Engineering Change Notification

This notice is to inform you of a change to the following LCD products:

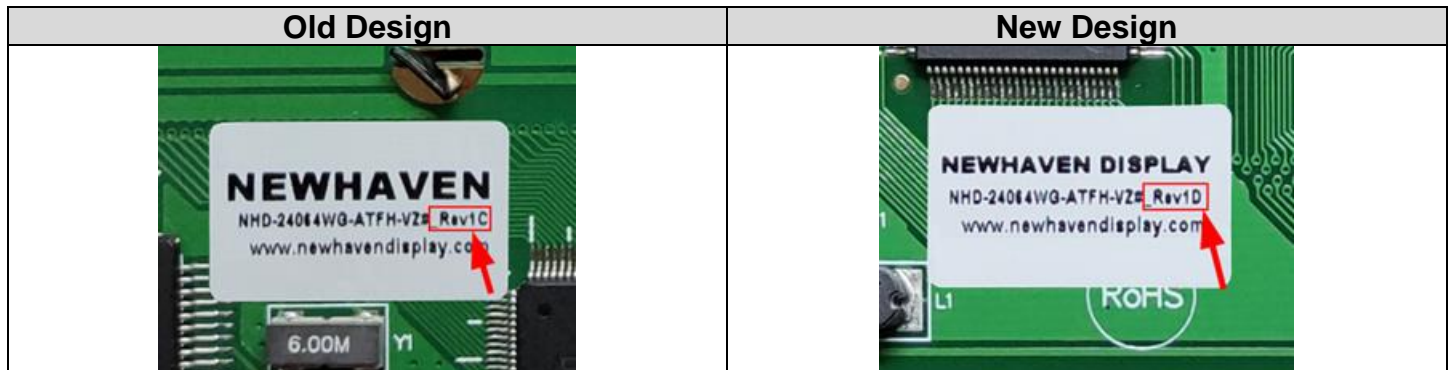
The RA6963-N controller IC used in these displays has been discontinued and replaced by RA6963-N1, which is an alternative version of the same controller.

The new version will be labeled with a different revision control number after the part number. See example below. The same revision control number may not apply for all models.

All our testing found the new version to be backwards compatible with existing systems.

We understand that every customer's application is unique, and therefore recommend you test and validate samples of the updated design.
